Application No.	Applicant(s)			
	10/821,926	LIN, SHENG-HSIUNG			
Office Action Summary	Examiner	Art Unit			
	Jon A Szumny	3632			
The MAILING DATE of this communication appears on the cover sheet with the correspondence address Period for Reply					
A SHORTENED STATUTORY PERIOD FOR REPLY THE MAILING DATE OF THIS COMMUNICATION. - Extensions of time may be available under the provisions of 37 CFR 1.13 after SIX (6) MONTHS from the mailing date of this communication. - If the period for reply specified above is less than thirty (30) days, a reply If NO period for reply is specified above, the maximum statutory period w Failure to reply within the set or extended period for reply will, by statute, Any reply received by the Office later than three months after the mailing earned patent term adjustment. See 37 CFR 1.704(b).	36(a). In no event, however, may a reply be time within the statutory minimum of thirty (30) days will apply and will expire SIX (6) MONTHS from cause the application to become ABANDONEI	ely filed s will be considered timely. the mailing date of this communication. O (35 U.S.C. § 133).

This is the second office action for application number 10/821,926, Angularly Adju

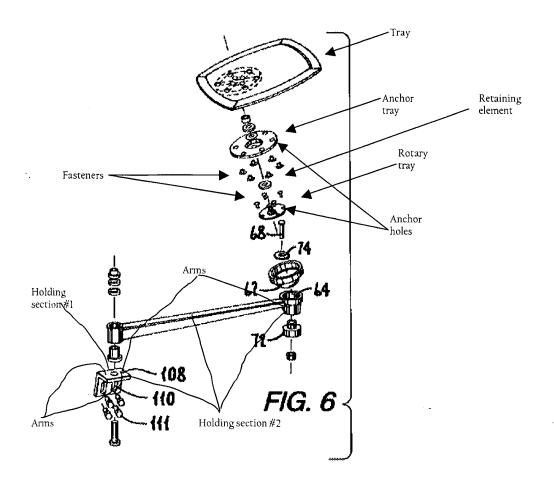
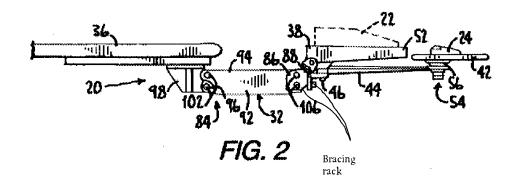
Regarding claims 1, 6, 9 and 10, McAllister et al. '034 discloses an angularly adjustable support bracket (figures 2-6) comprising a mounting rack (98) attached to a desktop, a movable arm (32) coupled with the mounting rack through a first pin (102) and a bracing rack (above)

coupled on another end of the movable arm through a second pin (106); wherein the bracing rack includes a holding section (above, holding section #1) at a top of the bracing rack; wherein the bracket includes a tray (above); wherein a rotary mechanism is attached to and held by the holding section; wherein the rotary section is located between the holding section and the tray; wherein the rotary mechanism includes an anchor tray (above), a rotary tray (above), and a retaining element (above) located between the anchor tray and the rotary tray, wherein the tray is fastened to the anchor tray, wherein the rotary tray is fastened to the holding section (via arm 44), wherein the anchor tray, the rotary tray and the retaining element having respectively a hole aligned along an axis (see above) that receives a bolt (112); wherein the rotary mechanism inherently allows a tray to swivel to a left side and a right side to an angle relative to the holding section of the bracing rack and the rotary tray to provide users with a desired operating angle, wherein the holding section of the bracing rack/section is horizontally non-pivotable to the movable arm (inherently, with holding section #1 above), wherein the tray is inherently a keyboard tray (a "keyboard tray" is read as a "tray for a keyboard", so clearly, the "keyboard tray" of McAllister et al. '034 could function as a "keyboard tray"), wherein the holding section includes two arms (above) separated from each other.

Regarding claims 4, 5 and 8, McAllister et al. '034 alternatively teaches a holding section (as in holding section #2 above), wherein the rotary tray and the anchor tray respectively have first and second anchor holes (above) that each receive a fastening member (above) to run through the holding section of the bracing rack and the tray; wherein during swiveling of the tray relative to the holding section, the rotary tray is fixed and non-movable relative to the holding section; wherein the holding section includes two arms (above) separated from each other.
